FIGURE 1095(5)-ROL2: Proposal Plan

INFORMAL INFORMATION REQUEST

D/27-2017, ROL APPLICATION, 2 LOTS INTO 21 LOTS

Lots 253 and 254 SP241210 – EDENBROOK STAGE 5(A & B)

EDENBROOK STAGE 5
STORM WATER PRE AND POST DEVELOPMENT FLOWS
PRE DEVELOPMENT DOWN STREAM FLOOD DEPTHS
FIGURE 1095(5)-IR2
23/06/17 Rev 1

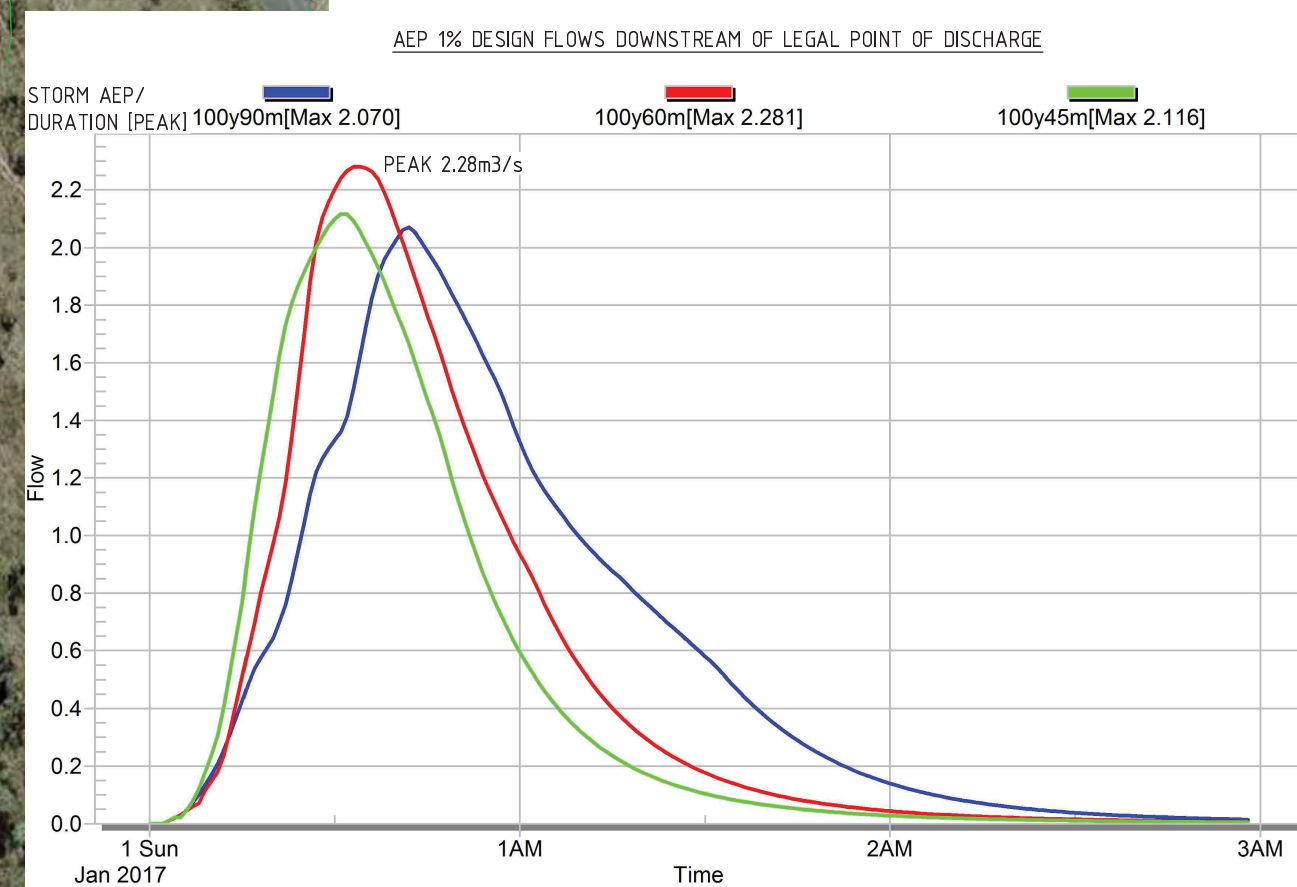
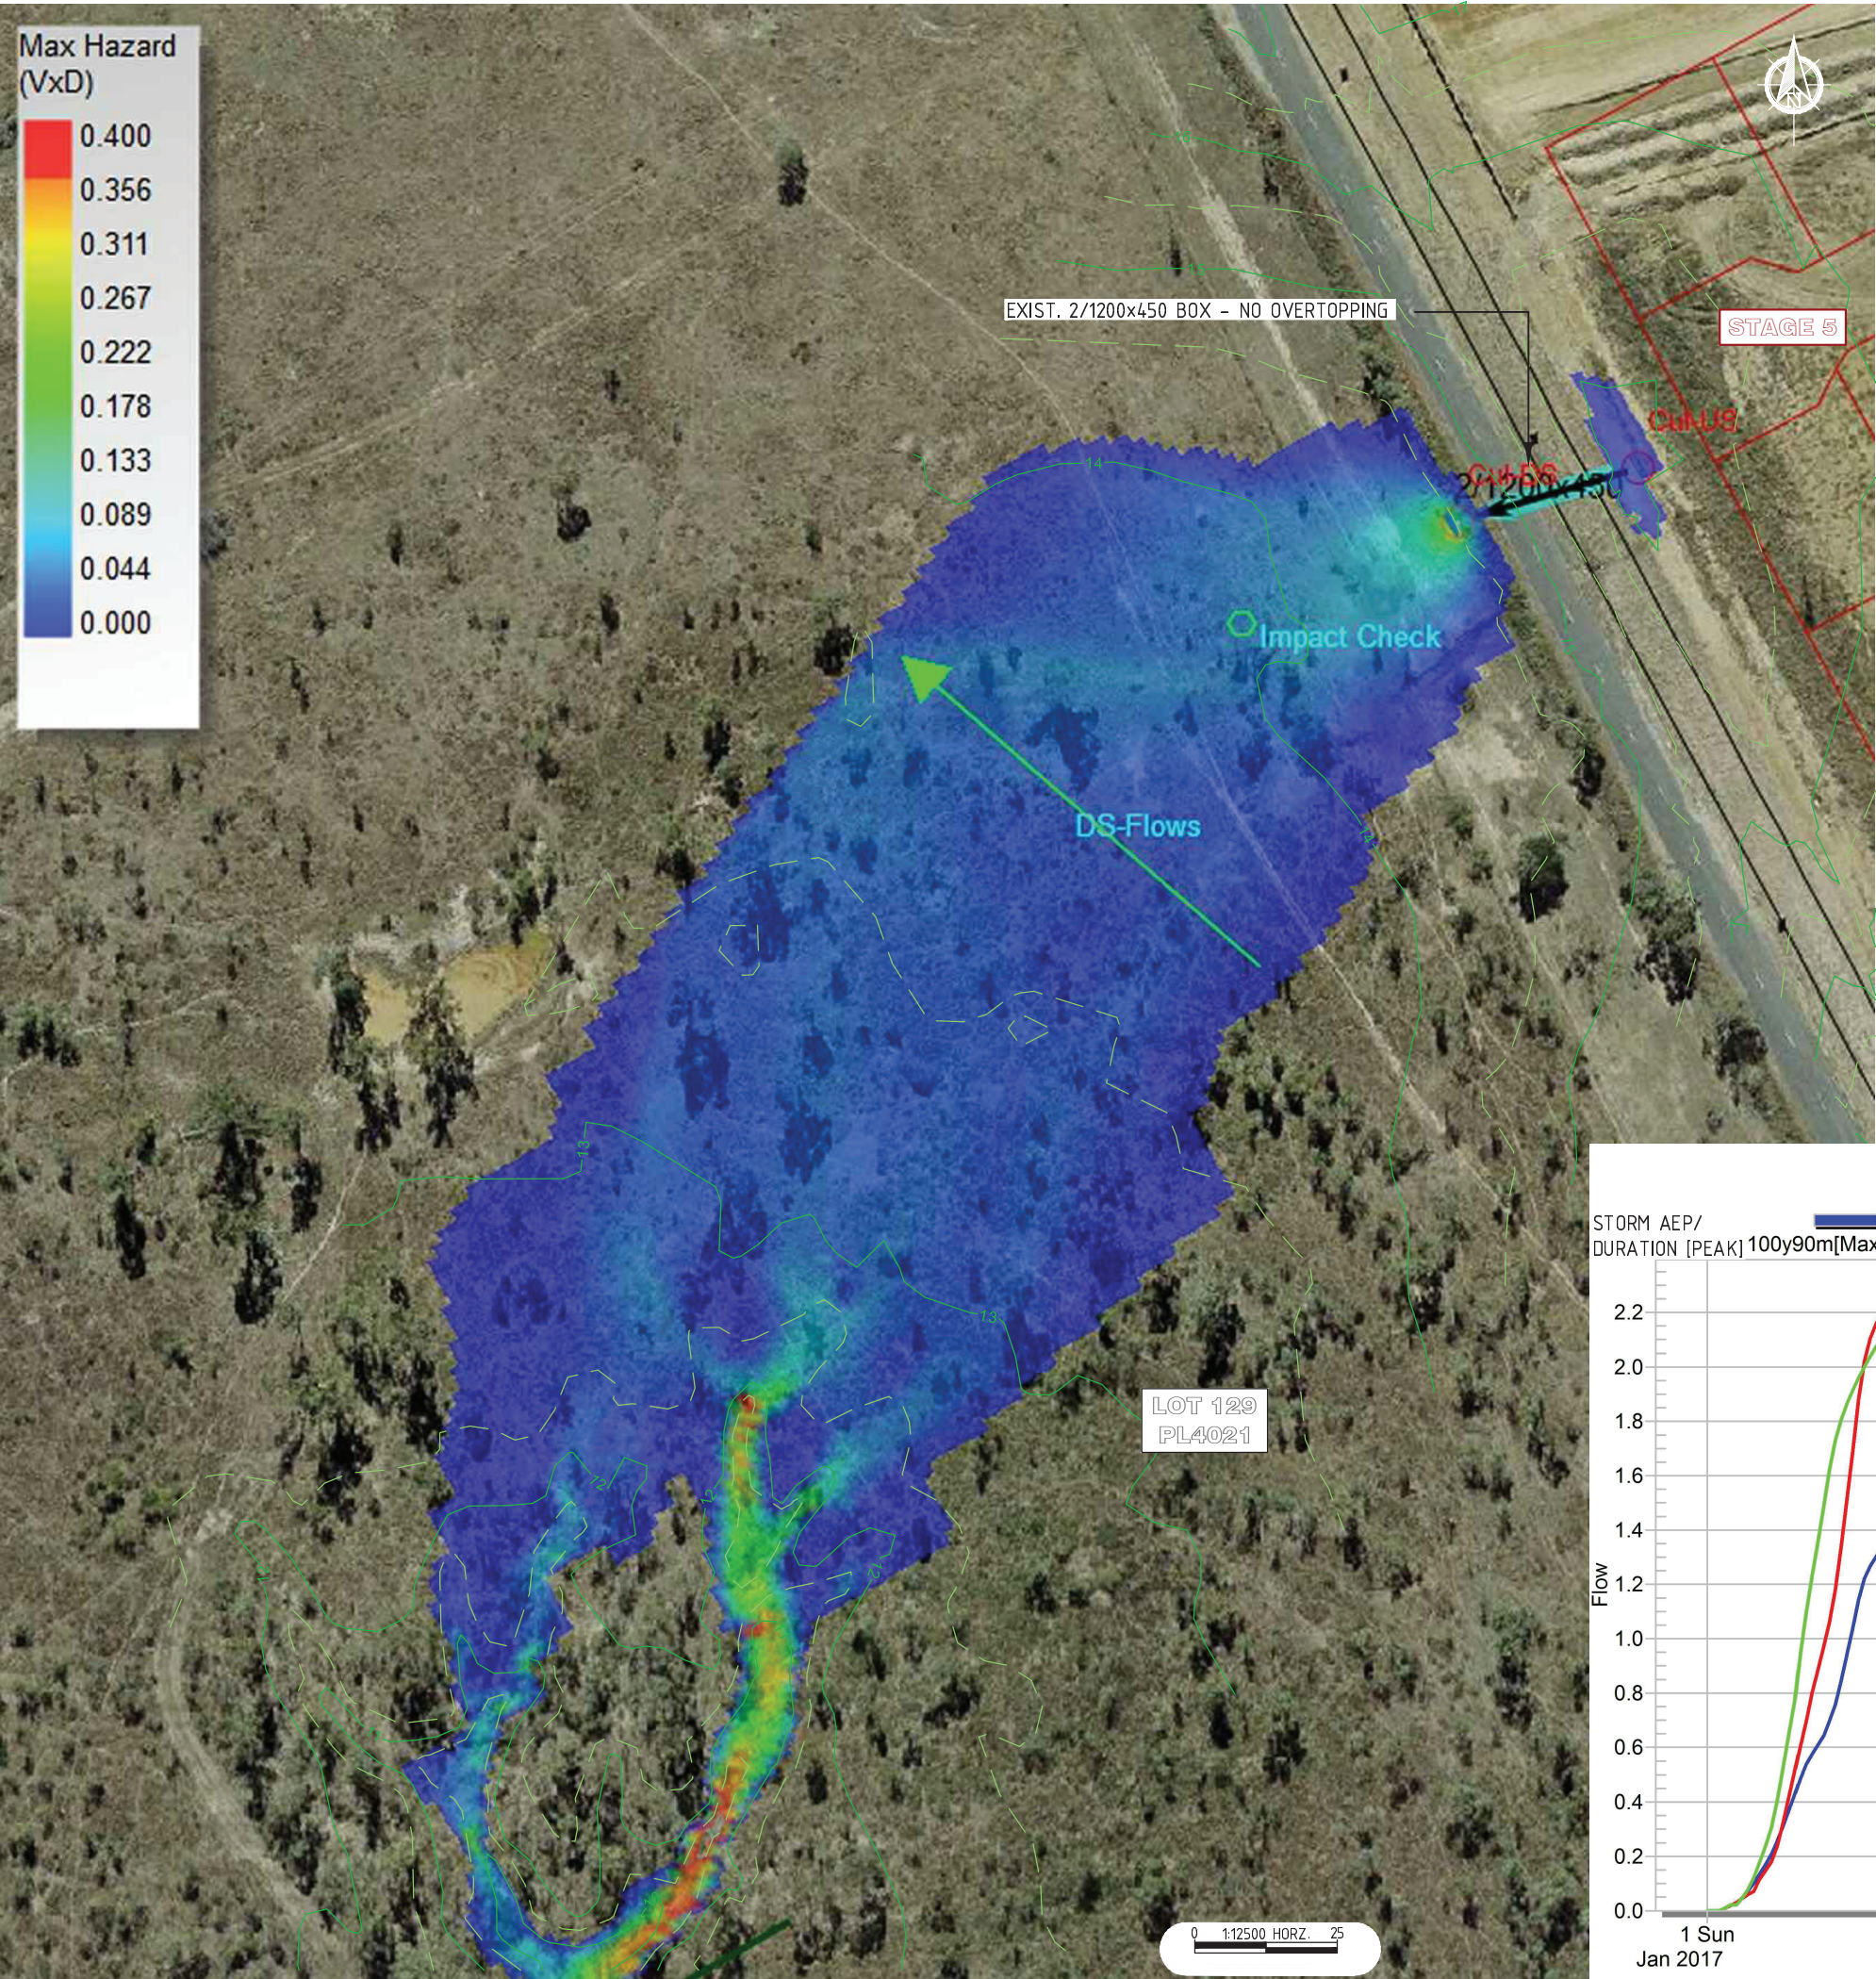
- 2.3 This portion of Belmont Road is not affected by Q100 Riverine or Ramsay Creek flooding. Provides detailed engineering calculations demonstrating the adequacy and suitability of existing culvert. If overtopping is proposed please provide the DV product.*

- C. FIGURE 1095(5)-IR2 provides the modelling output for the PRE DEVELOPMENT DOWNSTREAM FLOOD DEPTHS and the flow hydrographs for 3 different Q100 storms showing the maximum peak discharge is 2.28 cumecs. This output also shows that there is no overtopping of the road; that the existing culvert has Q100 capacity and that the flow depths are basically less than 150mm downstream of the culvert outlet.
